## TECHNICAL UPDATE – AC & DC Power Options

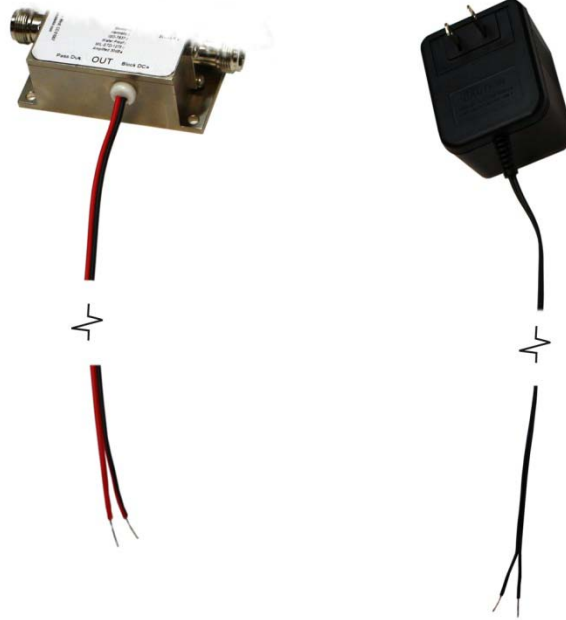
Previously we put Anderson Power Pole quick connects on the DC wires from the product and put the same mating quick connects on the positive and negative wires on the AC Adapter. We also provided an extra pair of quick connects that could be attached to the positive and negative wires from the customer's DC source. However, we decided to change this option because many customers did not have the proper crimp tool to add these quick connects or used different quick connects.

To provide the most effective solution to the widest range of our customers, we have decided to ship products with tinned leads for DC only or the AC & DC option with the red wire being positive and the black wire denoting negative.

For the AC & DC option, the power supply will also be shipped with tinned leads so the end user can decide what is the most effective means of connecting them to the product (with or without the connects of their choosing). Each power supply has the positive and negative polarization of the wires clearly marked to avoid potential problems connecting the wires.
